Mode Partition Noise Handling in Spreadsheet Model

Problem Statement and Solution

- Appropriate change in Pcross needs to be made (column S):

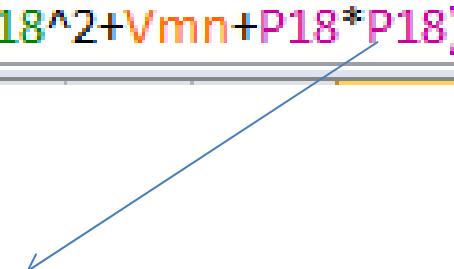
P18 moved inside inner parenthesis, divided by AA values (ISI)

Before:

```
=-10*LOG10(AA18*SQRT(1-Q*Q*((SD_blw^2+AK18)/AA18^2+Vmn+P18*P18)))
```

After:

```
=-10*LOG10(AA18*SQRT(1-Q*Q*((SD_blw^2+AK18+P18^2)/AA18^2+Vmn)))
```
